Docket Number:	18-IRP-01
Project Title:	Integrated Resource Plan
TN #:	230831
Document Title:	Updated - Staff Paper - Review of City of Palo Alto Utilities' 2018 Electric Integrated Resource Plan
Description:	** This document supersedes TN# 229744 for accessibility purposes. **
Filer:	Courtney Wagner
Organization:	California Energy Commission
Submitter Role:	Commission Staff
Submission Date:	11/22/2019 9:06:27 AM
Docketed Date:	11/22/2019

STAFF REPORT

Review of City of Palo Alto Utilities' 2018 Electric Integrated Resource Plan

Gavin Newsom, Governor
September 2019 | CEC-200-2019-016

Figure 1: Palo Alto and Energy Commission Energy Forecasts 2018-2030 (GWh)

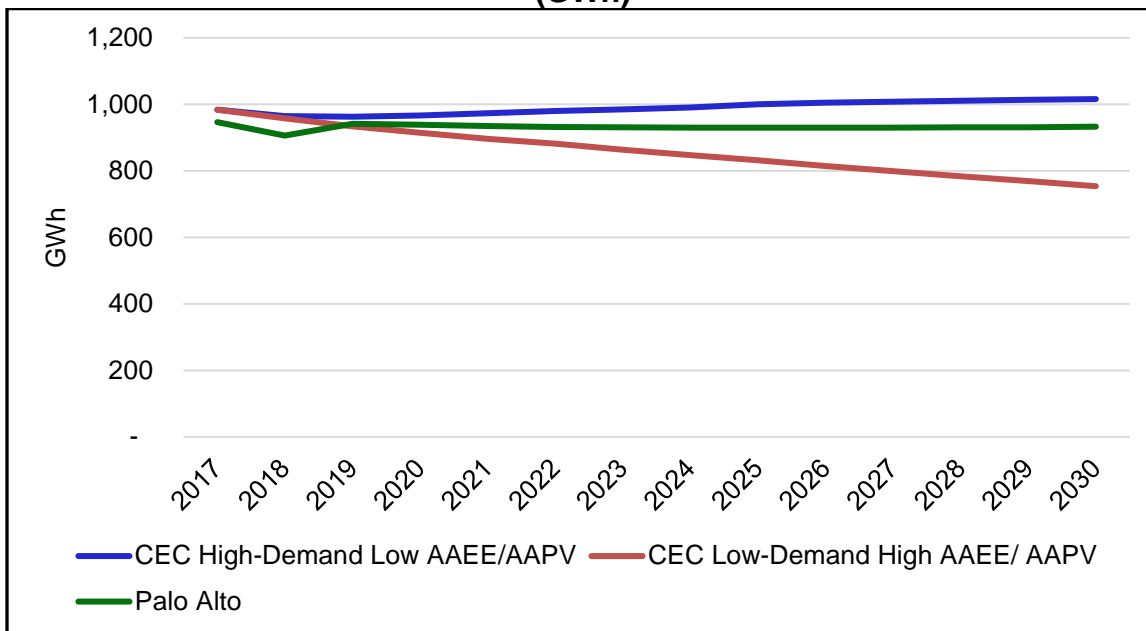
Staff compared Palo Alto's energy and peak demand forecasts to the CEC's *2018 Demand Forecast Update* report. As shown in **Figure 1**, Palo Alto's energy demand forecast lies between the CEC's high-demand low AAEE/AAPV (high) forecast and the low-demand high AAEE/AAPV (low) forecast, and decreases slightly over the planning period (roughly 1 percent annual average decrease).

The utility's forecast accounts for variables that can reduce demand: increased energy efficiency, rooftop solar, demand response, and energy storage. The forecast also includes variables that can increase demand: increased EV load and electric heat and water pump usage. The utility's forecast appears reasonable for long-term planning, given it is similar to the CEC demand forecasts.

Figure 2: Sources of Renewables Portfolio Standard Eligible Energy 2019–2030 (MWh)

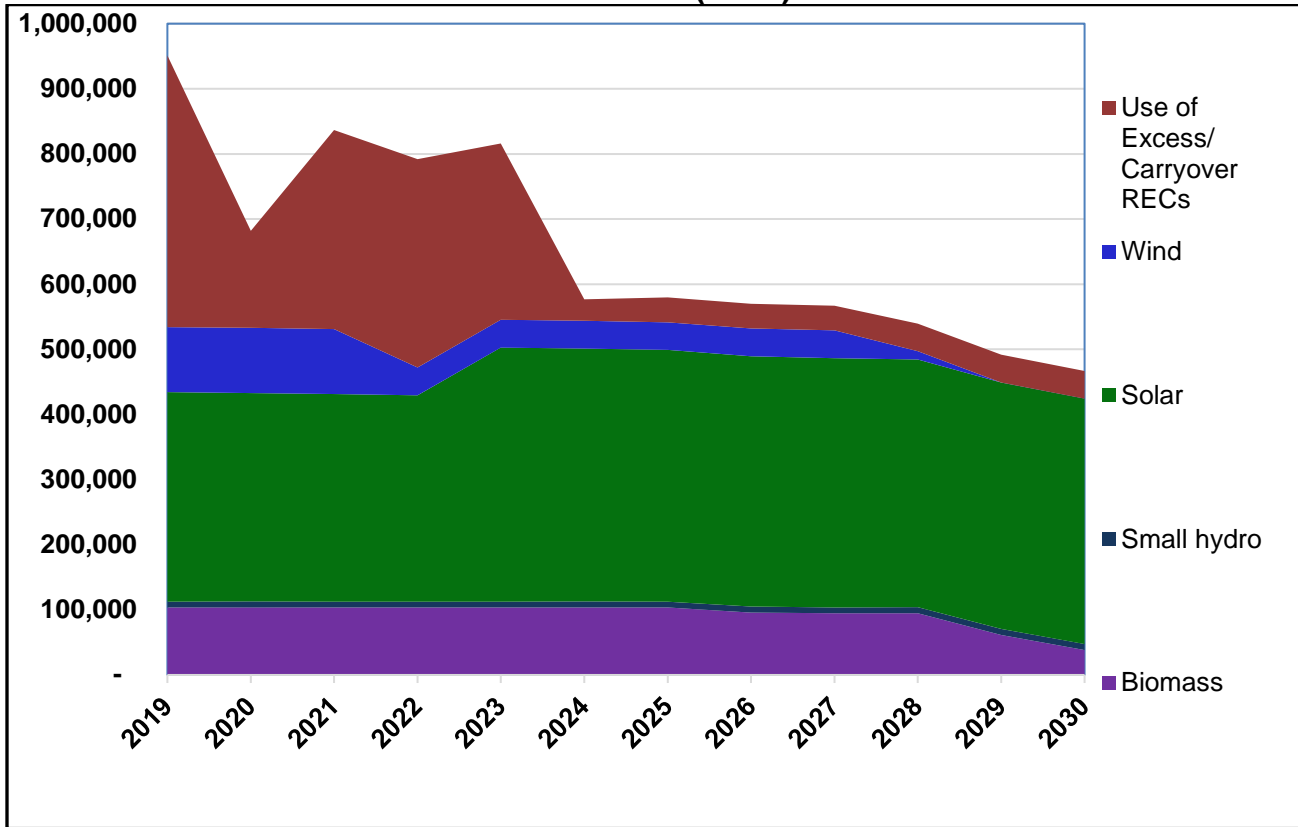
Figure 2 and **Figure 3** show Palo Alto’s renewable portfolio consists primarily of solar, with some landfill gas, small hydro, and wind. In 2019, solar makes up 60 percent of Palo Alto’s renewable resources, and by 2030 it makes up 89 percent.

Figure 4: Palo Alto Portfolio Comparison for 2019 and 2030

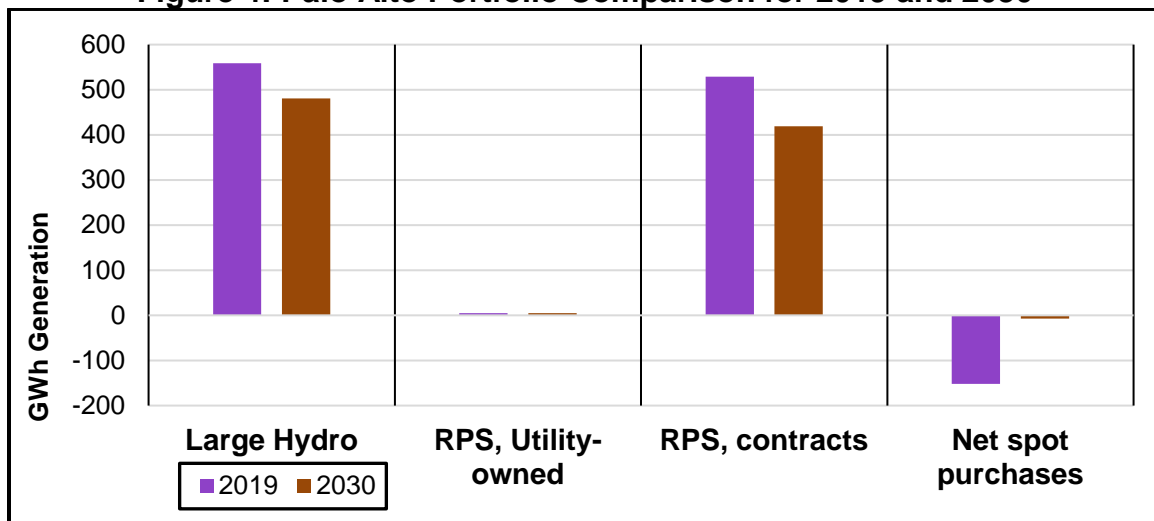
Figure 4 shows a comparison of the energy mix by resource in Palo Alto’s preferred portfolio in 2019 and 2030.

In 2030, the utility’s resource mix includes 53 percent large hydroelectric, 41 percent solar, 4 percent landfill gas, and 1 percent small hydroelectric and spot-market purchases. Palo Alto’s one natural gas resource is not included in **Figure 4** as it accounts for less than 0.03 GWh, or less than 0.003 percent, of Palo Alto’s resource portfolio.
